Work Zone Awareness Session

2013 Design Expo
•By: Ezzeldin Benghuzzi and Chris Lewis

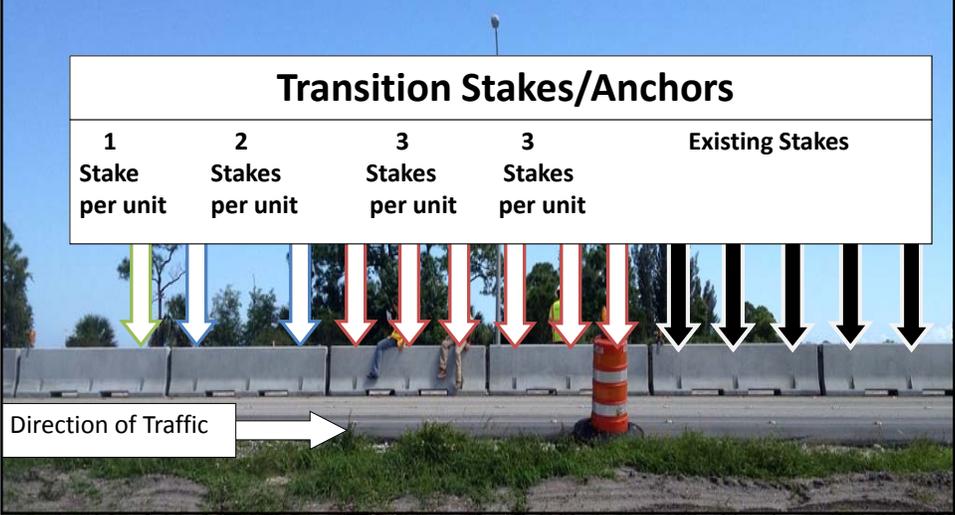
Barrier wall was not transitioned from freestanding to staked – Arrows below represent the transition pattern - **Index 414, Sheet 8** requires transition units anchoring pattern of **1, 2, 3, 3, staked/anchored**.

Nonstandard connection to bridge railing - **Index 414, Sheet 9** requires transition splice to connect Type K to bridge railing.

Deflection space behind low profile barrier is not free and clear of material [Index 412, Sheet 2 requires 9 inches deflection space]
